National Committee on Uniform Traffic Control Devices (NCUTCD)

Recommended Changes to Proposed Text for 11th Edition of the MUTCD

Docket Number: FHWA-2020-0001

NPA MUTCD Section Number: Sections 9D.01 – 9D.13

Figure 9D-1. Guide Signs and Plaques for Bicycle Facilities (Sheet 1 of 2)

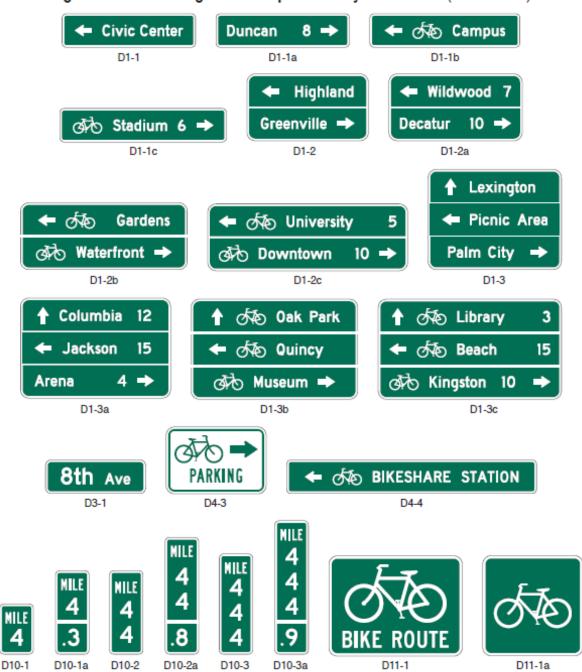
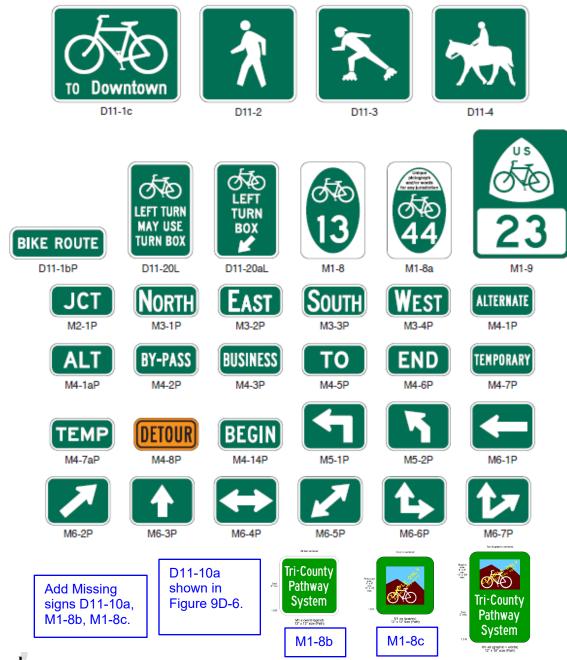
NCUTCD generally agrees with Figure 9D-1 as presented in the NPA, but recommends adding signs D11-10a, M1-8b, and M1-8c to Sheet 2 of 2 in accordance with NCUTCD recommendation 14A-BIK-02.

Figure 9D-2. Example of Bicycle Guide Signing (Sheet 1 of 2)

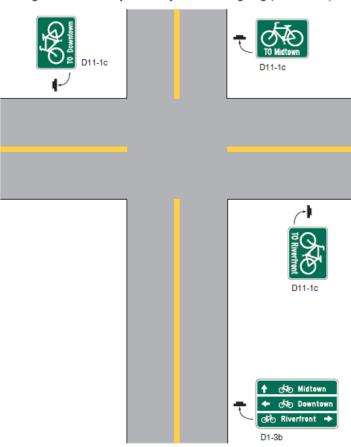
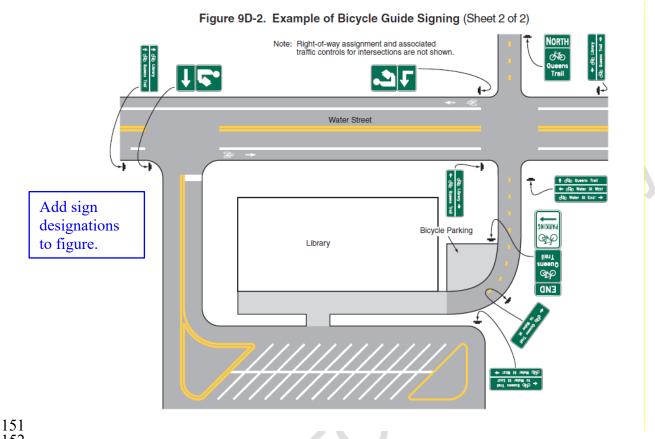
149 sign designations to Sheet 2 of 2.

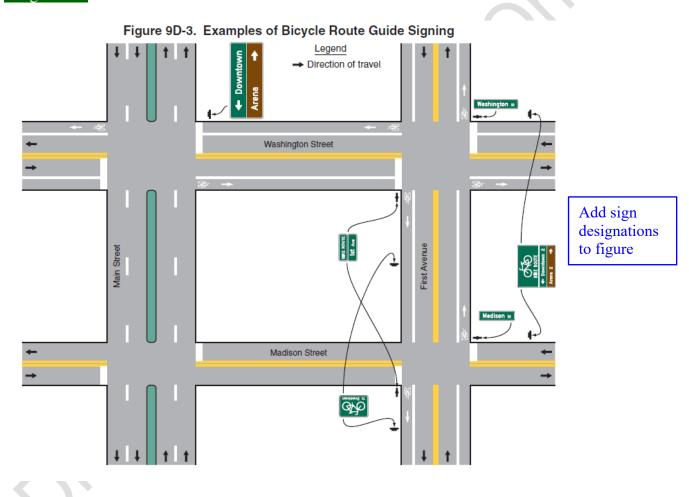
NCUTCD generally agrees with Figure 9D-3 in the NPA, but recommends adding sign designations.

Figure 9D-X. Illustration of Bicycle Route Directional Assemblies (for One Direction of Travel Only)

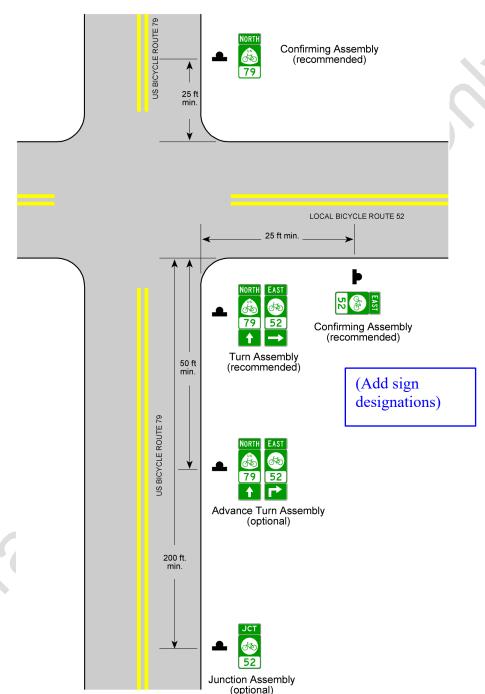
NCUTCD recommends adding a new Figure 9D-xx addressing bike route directional signing in accordance with NCUTCD recommendation 15B-BIK-01.

Figure 9D-5. Example of Mode-Specific Guide Signing on a Shared-Use Path

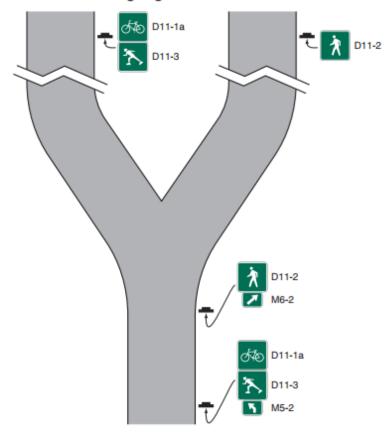
NCUTCD agrees with Figure 9D-5 as presented in the NPA.
